Product Change Notification

PCN #: 4B-2019

DATE: 23rd April 2019

Figure 1: Module label

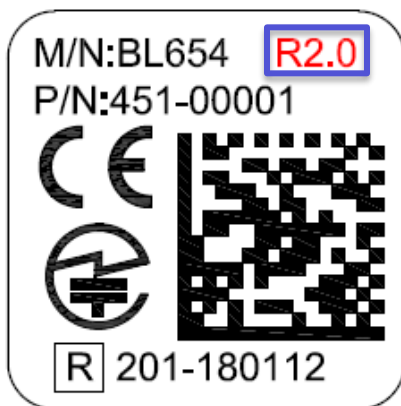
The change can be identified by reviewing the *Hardware Revision Code* number that is present on the individual module, reel label and carton label. The images below identify where this 'Hardware Revision Code is located on each of those labels.

A Hardware Revision Code that shows as R2.0 indicates that the nRF52840-QFAA-D00 silicon is utilised.

A Hardware Revision Code that shows as R1.0 indicates that the nRF52840-QFAA-C00 silicon was utilised.
